SERVICE BULLETIN REVISION NOTICE

NON-MODIFICATION SERVICE BULLETIN - ENGINE - SEAL, AIR, HPT, 1 STAGE - REPLACEMENT OF

Turbojet Engine Service Bulletin No. V2500-ENG-72-0678 Revision No. 1 dated January 5, 2017.

V2500 Series 72-0678

LOCATION OF THE 1ST STAGE HPT AIR SEAL
FIGURE 1

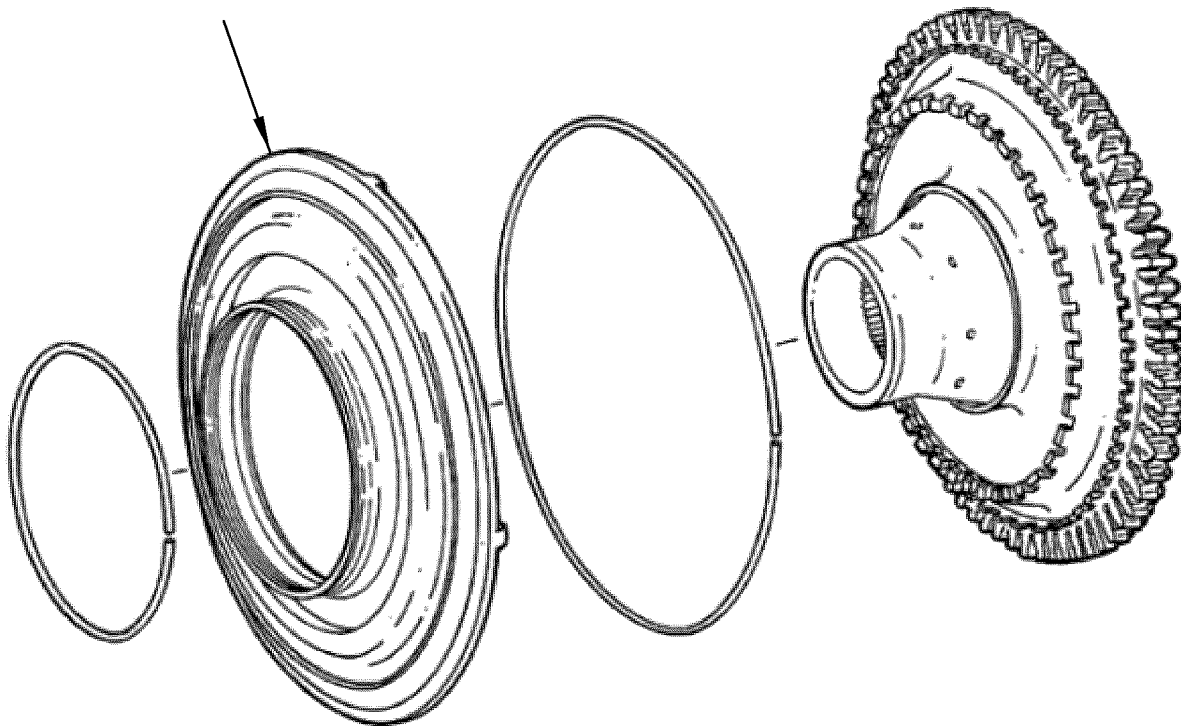
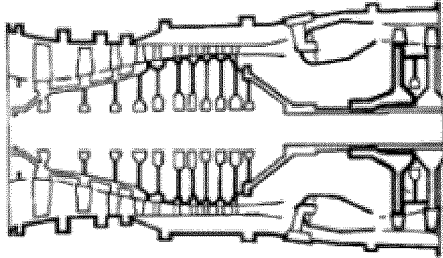
2A3423
1ST STAGE HPT AIR SEAL
REPLACE AS SPECIFIED IN THE
ACCOMPLISHMENT INSTRUCTIONS

1. Remove the suspect HPT 1st Stage Air Seal, PN 2A3423, identified by serial number in Table 1. Reference 5 or 6. Engine Manual, Chapter/Section 72-45-10.
 - A. The HPT 1st Stage Air Seal, PN 2A3423, identified by serial number in Table 1 must be either returned to IAE or scrapped locally. If scrapped, a photograph or digital image of the mutilated HPT 1st Stage Air Seal, PN 2A3423, and a copy of the scrap tag, countersigned by the local IAE representative, must be provided to IAE Warranty.
2. Install new non-suspect HPT 1st Stage Air Seal, PN 2A3423, when assembling the HPT Stage 1 Rotor Assembly. Reference 5 or 6. Engine Manual, Chapter/Section 72-45-10.
3. Recording Instructions
 - A. A record of accomplishment is required.
